THE SHELL — REV M

REV M · 22 SEP 2026 8:28 AM · CORRECTED FROM THE EXTERIOR SHOTS
ANCHORED ON THE 12×24 GARAGE

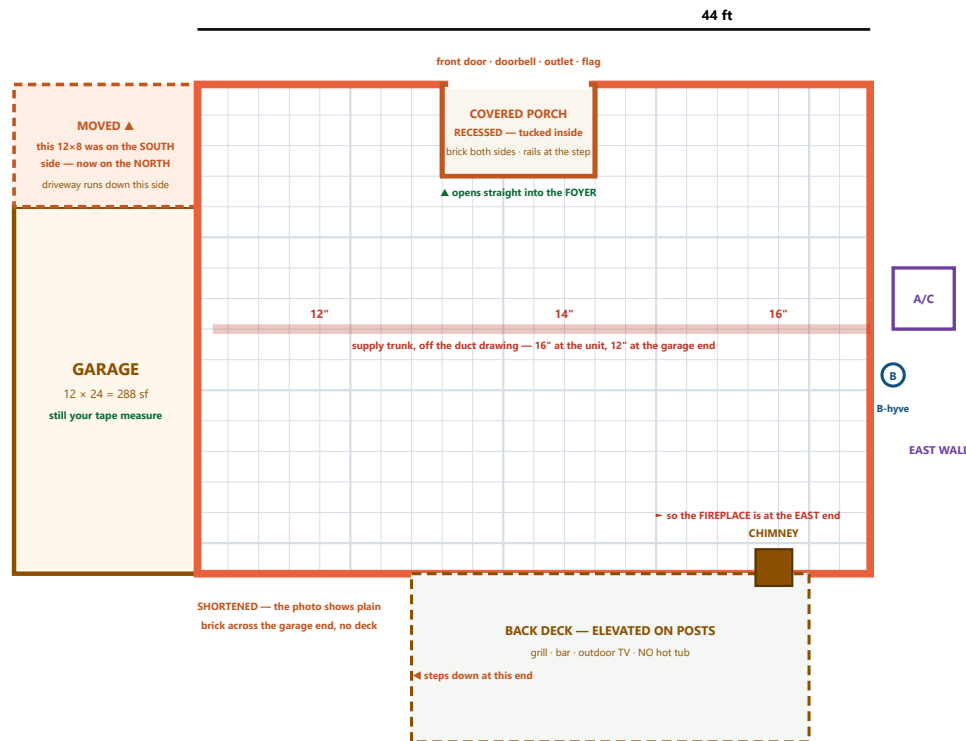
Porch redrawn RECESSED into the foyer — the front-door view proves it. The 12×8 moved from south of the garage to north, and the rear elevation backs you up. Deck shortened, chimney found on the east, hallway turned 90° so those two doors can face.

- ✓ **THE PORCH IS RECESSED** — you were right, and the front-door view proves it. Looking out from the front door there is **brick wall on BOTH sides** with the porch ceiling running over them, and railings only at the step opening. That is a porch **cut into** the footprint, not one hung off the front of it. Redrawn as a **10 × 6 notch in the north wall opening straight into the foyer** — “it tucks inside to where it comes into the foyer.”

- ✓ **The 12 × 8 moved from the south side of the garage to the north.** Garage is still exactly 12 × 24. **The rear-elevation shot independently backs you up:** the back wall is **continuous brick right across the garage end** — no notch, no step-back. Had that space still been on the south side there would be a visible jog in the back wall, and there is not one.

- ✓ **The back deck is SHORTER than I drew it.** Same photo: the deck starts about a third of the way along the rear and runs east. The whole garage end of the back wall is **plain brick with one small window and no deck**. Was 40 ft, now **26 ft**, with the step-down at its west end where the photo shows it.

🔍 **One more thing that shot settles: THE CHIMNEY IS ON THE EAST HALF OF THE ROOF.** So the **fireplace** — and the living room with it — **sits at the EAST end**, not in the middle where I had been drawing it. Marked on the plan. This is what you meant by pulling it all together: the picture knows where the fireplace is.

✓ **"the doors in the guest bedroom and the office are straight across from each other"** — taken. That is only possible with the hallway as a **4 ft wide, 18 ft long spine** and those two rooms on either side of it, so **the hallway tile is turned 90°** on this sheet.

✓ **"the living room southwest corner is really the office — I told you wrong"** — also taken. But that puts the **office in the SOUTHWEST**.

► **The conflict:** you also told me the **RE200 is in the office, and the B-hyve is on the outside wall of the office, through the brick** — and the B-hyve is on the **EAST** wall, which you confirmed separately. **The office cannot sit in the southwest and share a brick wall with the B-hyve on the east.** One of the two is off, and I am not picking for you.

Put the OFFICE tile where it really goes and everything else falls in behind it — guest bed goes across the spine from it, and the living room takes what is left around the fireplace at the east end.
